# **Final Environmental Statement**

**related to the operation of  
Braidwood Station,  
Units 1 and 2**

**Docket Nos. STN 50-456 and STN 50-457**

**Commonwealth Edison Company**

Figure 4.1 Location and orientation of principal plant structures  
Source: ER-OL Figure 2.1-4

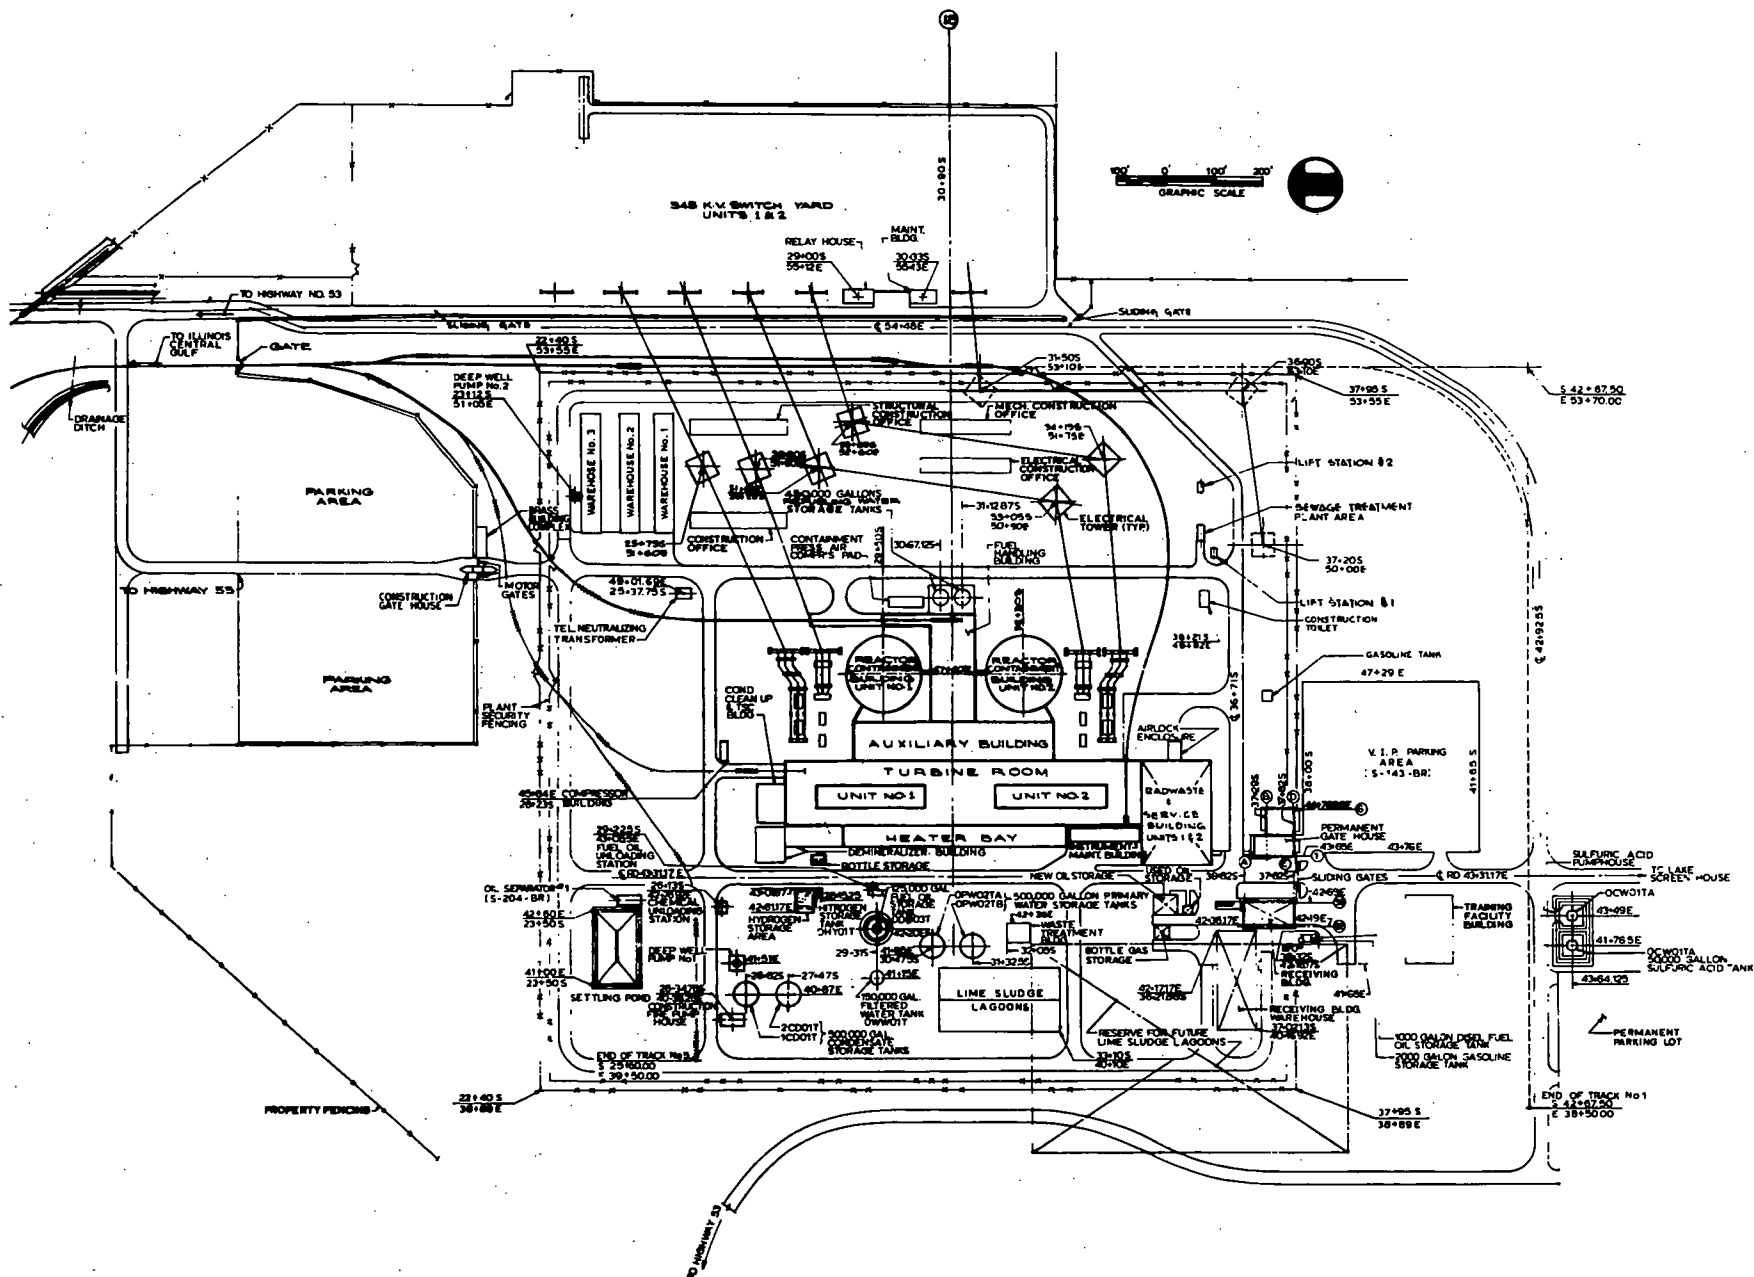
CECo 3: CECco stated that Figure 4.1 has been revised.

Staff Response: The revised figure has been included in the FES (Figure 4.1).

Figure 4.4 Braidwood Station cooling pond  
Source: ER-01 Figure QE 290.7-1

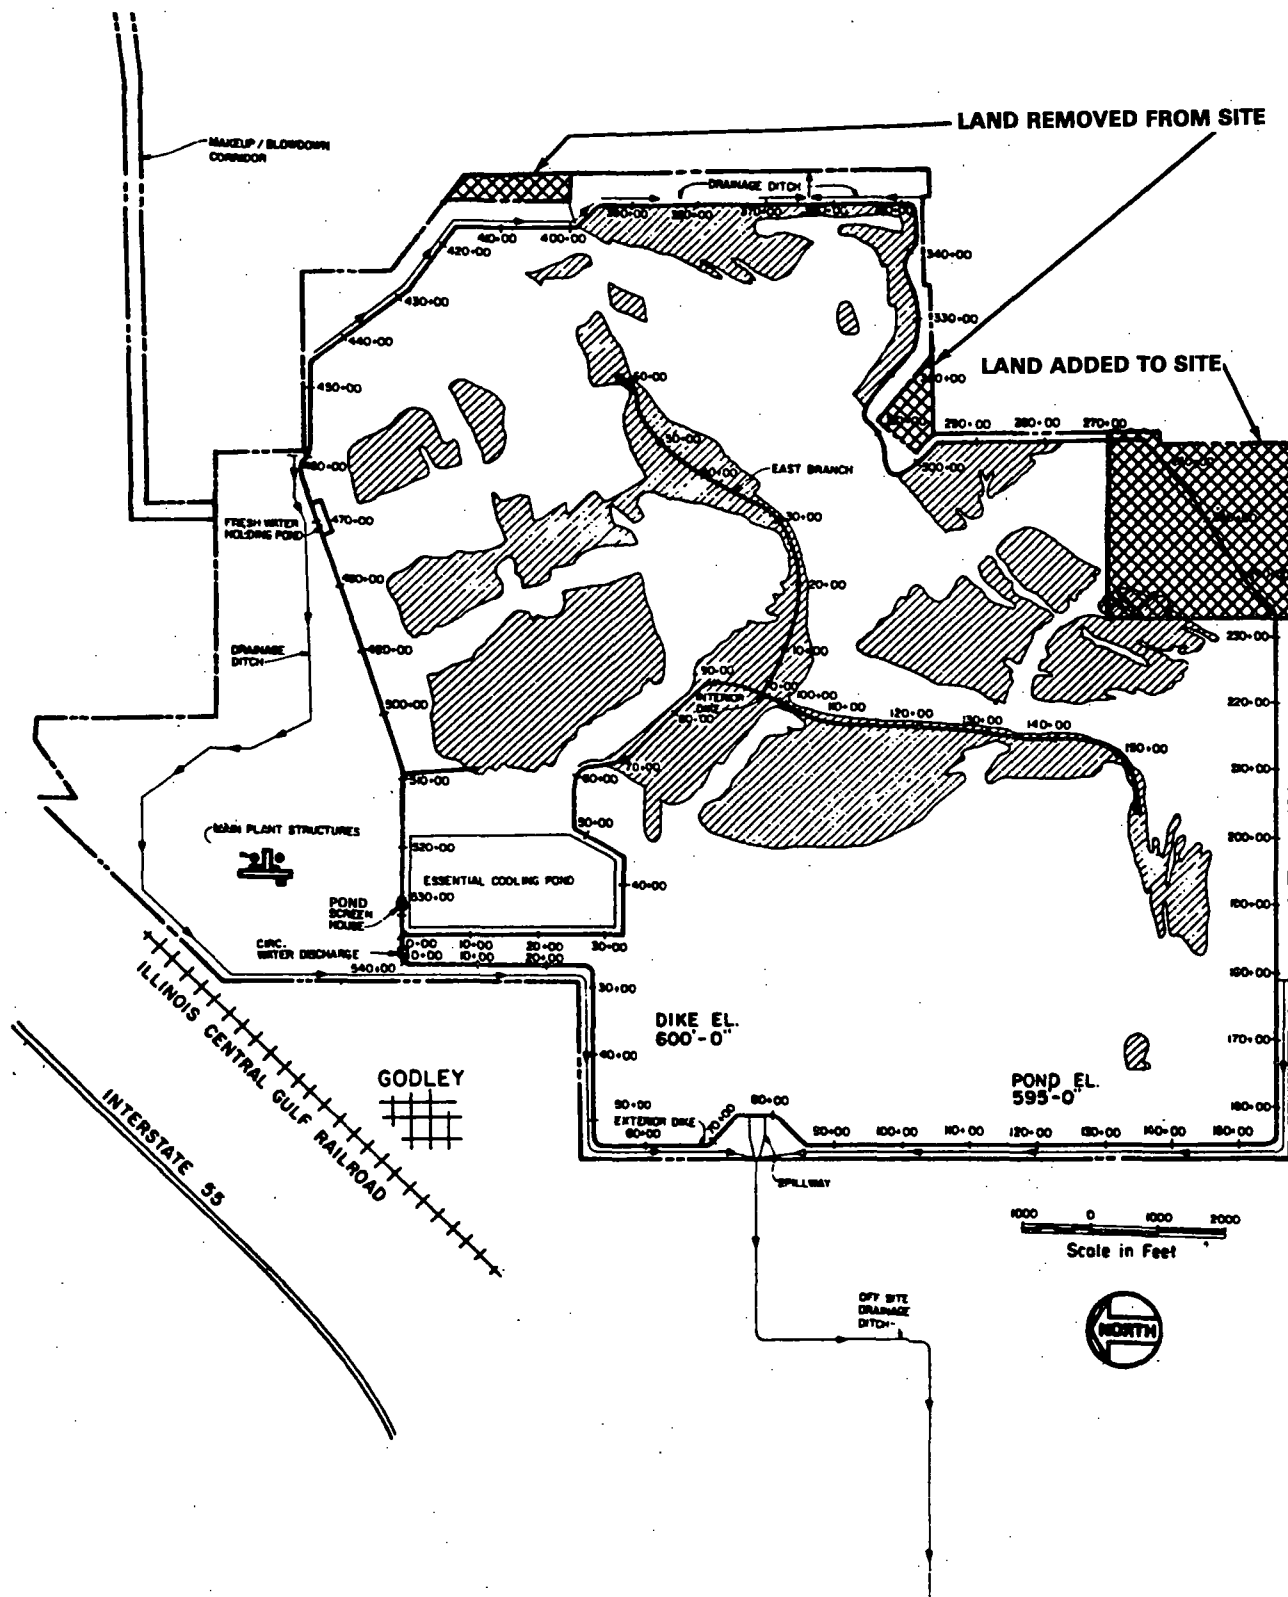
Staff Response: The basis for the staff's reference to a 30-m maximum depth is a discussion between the staff and applicant personnel during the environmental site visit in May 1983. Applicant's response to staff question E291.8 did not substantiate this value, however. This response included a map entitled "Braidwood Lake Topographic Map-Index Braidwood Station Units 1 and 2, Commonwealth Edison Co., Chicago, Illinois" (Sargent and Lundy Engineers drawing No. S-450-BR Rev A). This map showed standing water in several areas of the cooling pond. Depth measurements were taken at five transects in the vicinity of dike stations 450+00 - 480+00, as shown on FES Figure 4.4. These transects indicate depths as great as about 14 m (45 ft). The maximum depth value in Section 4.2.4.2 has been changed to indicate this deepest verified value.

The areas of greater depth indicated to the staff during the site visit are located in the region of the cooling pond traversed by a line drawn between perimeter dike station 130+00 and interior dike station 150+00, as shown on FES Figure 4.4.
